Spokane Park Board Agenda

3:30 p.m. Oct. 11, 2018

Design-Build Change Order Form

Change Order Number: 9	Change Order Effective Date: 10/15/18 (date when executed by both parties)
Project: PAVILION DESIGN BUILD PROJECT	Design-Builder's Project No: 172100
	Date of Agreement: APRIL 13, 2017
Owner: CITY OF SPOKANE - PARKS & RECREATION DIVISION	Design-Builder: GARCO CONSTRUCTION, INC.

Exterior Railing

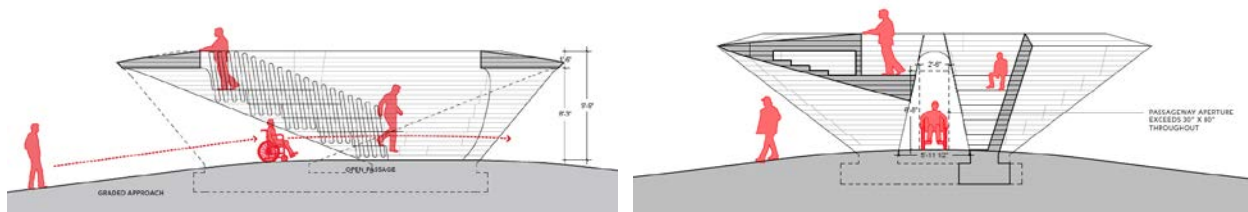
- The exterior railing design is altered to accommodate a change in the height of the tiers, which should now be more comfortable for sitting

- The artist didn't want the upper railing to be perceived as separate from the rest of the sculpture; she wanted to build it into the form of the sculpture instead of having it look like a separate element
- In addition, adding thick timber at the top would have taken the art work beyond budget
- The height from the top step to the upper edge of the sculpture is the typical safety railing height of 42"
